Service Bulletin

Bulletin No.: 18-NA-054

Subject: Momentary Sharp Deceleration During 1-2 Upshift or a Momentary Neutral During 2-4 Upshift, Transmission Stuck in 2nd Gear (fluid below 32°F), Malfunction Indicator Lamp (MIL) Illuminated - DTC P2820 and/or P2821 Set During Cold Ambient Temperatures

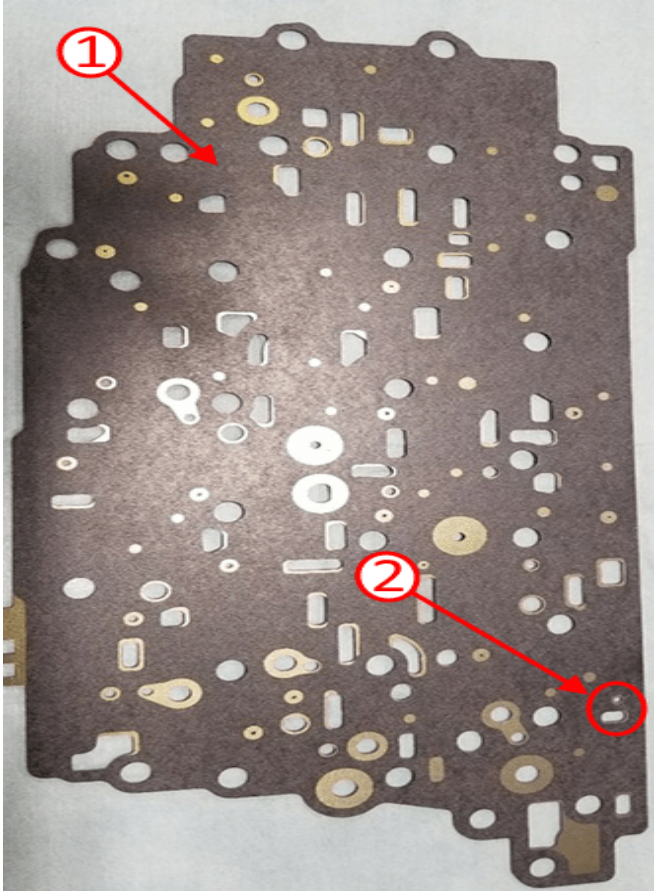
<p>Cause</p>	 <p style="text-align: right;">4885522</p> <p>This condition may be caused by the spacer plate (1), located between the valve body and the transmission case, containing an undersized orifice (2).</p> <p>⇒ The consequence is the clutch select moves slowly to release the selectable one way clutch, which causes a momentary transmission tie up during the 1-2 upshift.</p>
<p>Correction</p>	<p>Inspect valve body spacer plate orifice for proper size and replace as necessary following current SI instructions.</p>

- If the hole is 0.5 mm, replace the spacer plate.

- If the hole is 2.0 mm, refer to SI for further diagnostics.

Refer to *Control Valve Body Plate Disassemble* located in the *Control Valve Body Assembly Disassemble* in SI.
